Subject: RE: Thirley Cotes NYM/2018/0499/LB

Both Maria Calderon (Building Conservation Officer) and I have now had the opportunity to consider the revised plans and overall, are happy with the revised plans, subject to the following minor alterations and additional information:

Section A / A - Mulberry

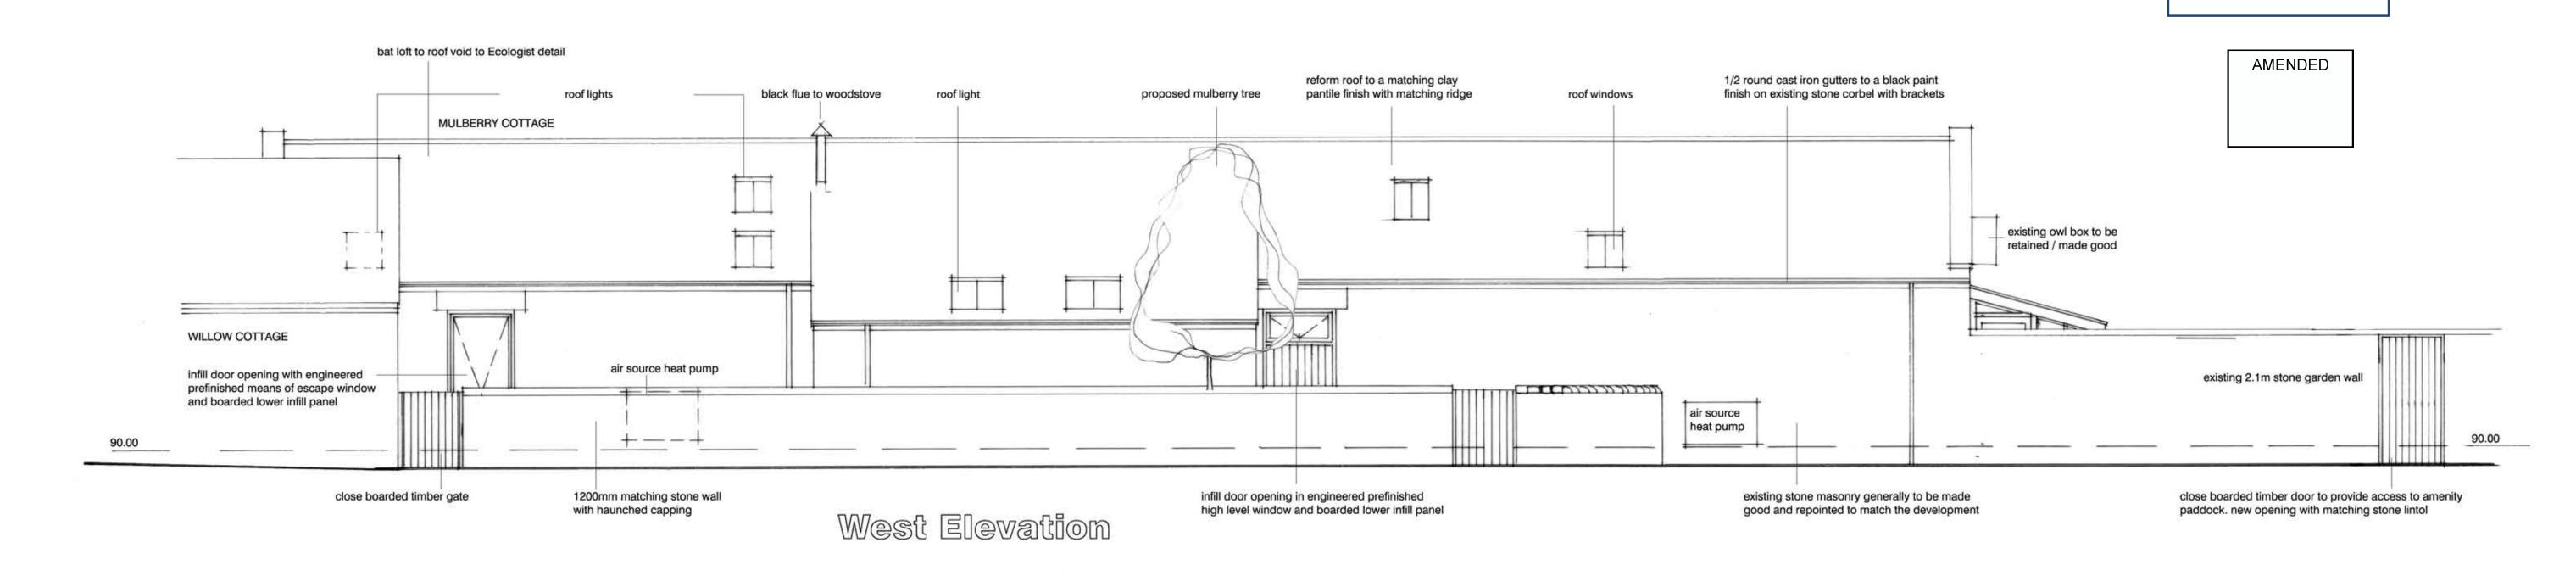
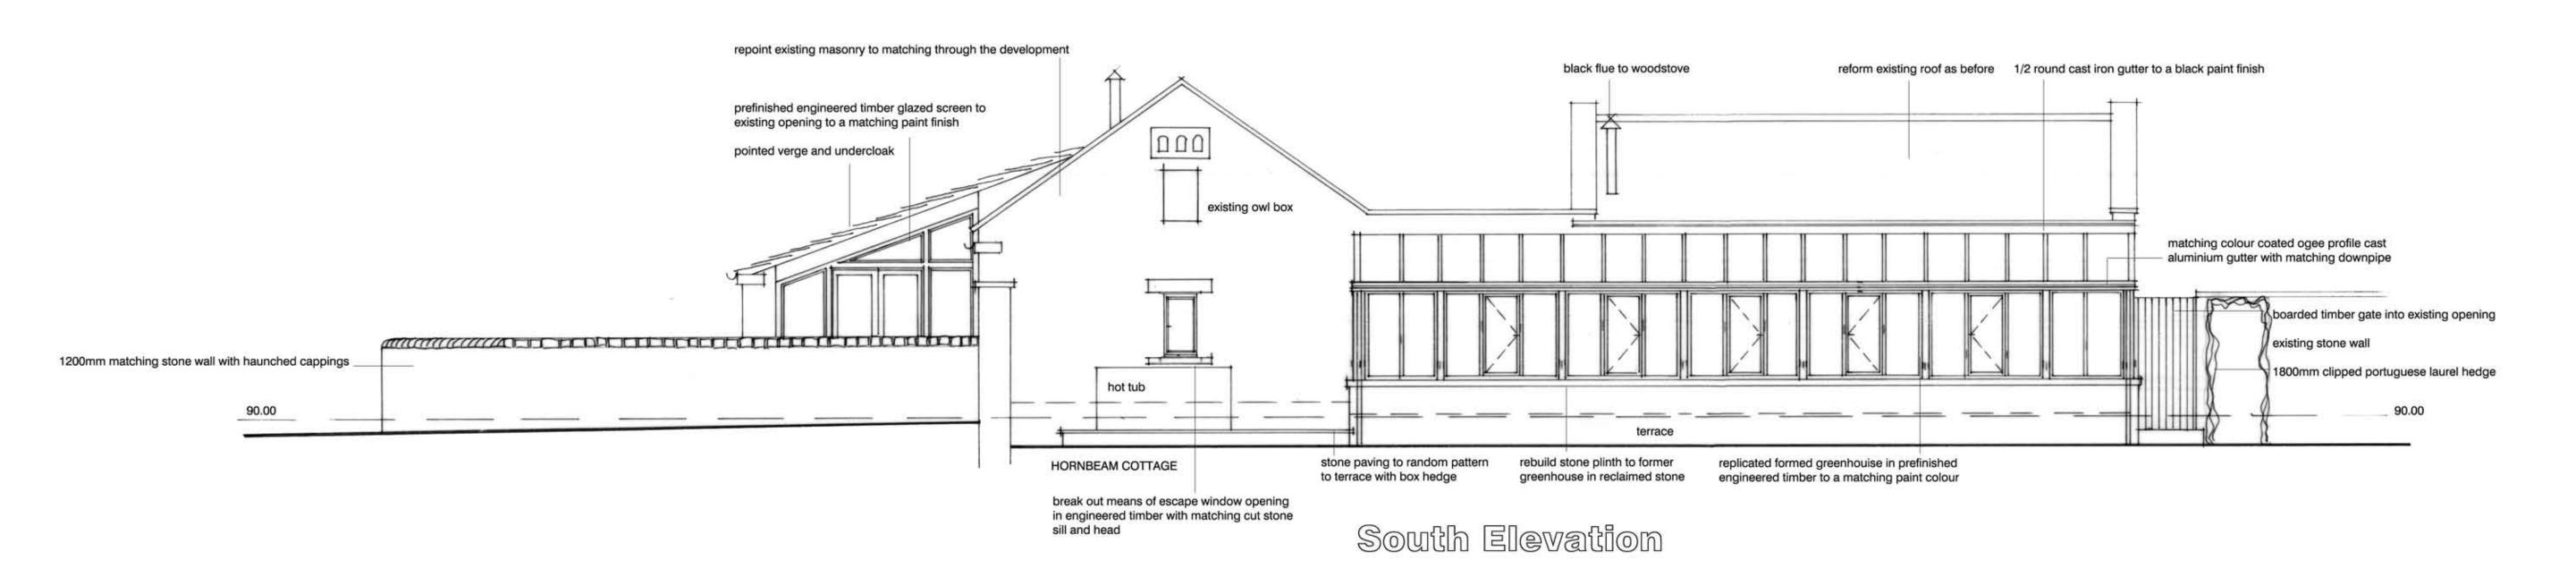
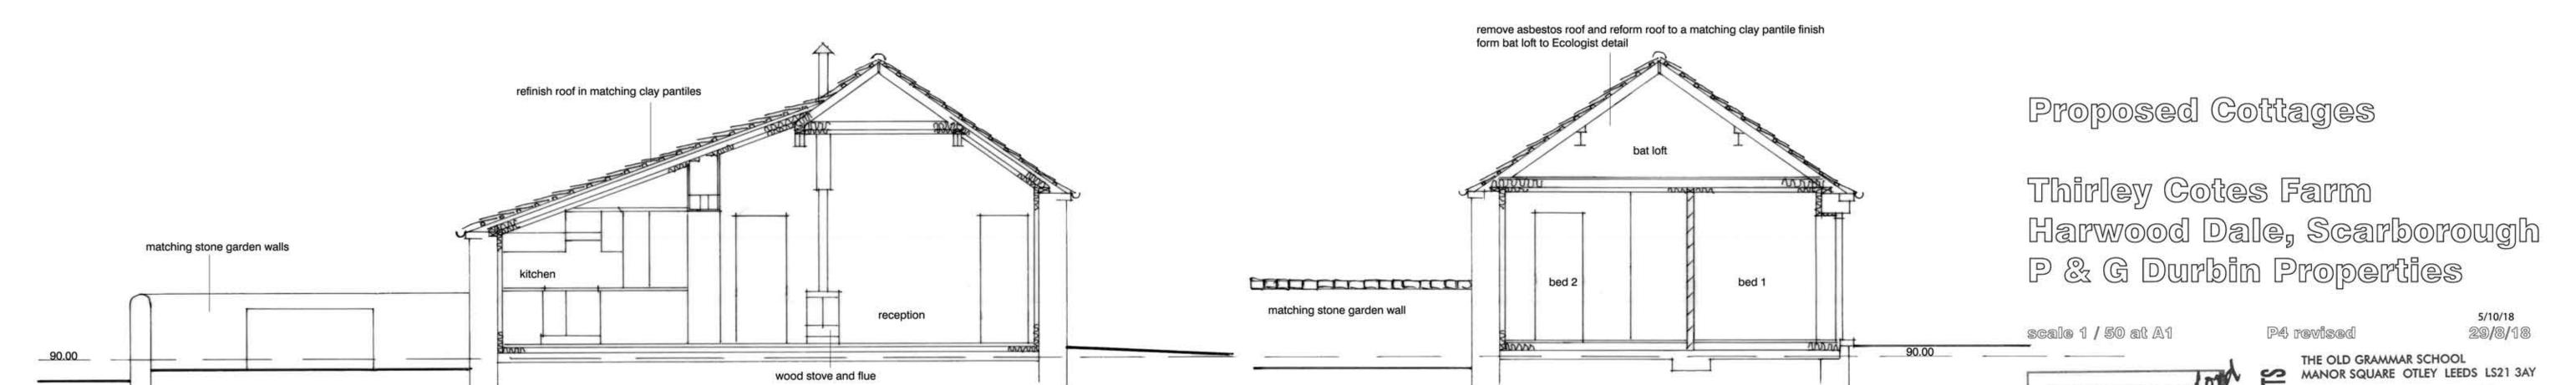
Veluxes - we do not permit the instillation of Velux Conservation Rooflights. I have attached a list of suppliers of conservation rooflights that we feel are more appropriate. However, the size of P10 appears to be quite intrusive and should be reduced in size. Also their placement should be altered so that they appear less regular.

- 2. Concerning roof windows I would propose 'the conservation range' from the Roof Light Company with CR10 / 517mm x 980mm to all the roof lights except over the kitchen to Rowan and Mulberry to be CR14's / 821mm x 1133mm. I have revised the drawings and moved a couple to reduce regularity.
- 3. On Hornbeam I have shown the owl box removed as this will not be needed once the owl loft above is in use. I have also reduced the size of the window it does need to be suitable for means of escape.
- 4. Concerning flues I have put a general note on the drawings advising that they are to be kept as low as possible.
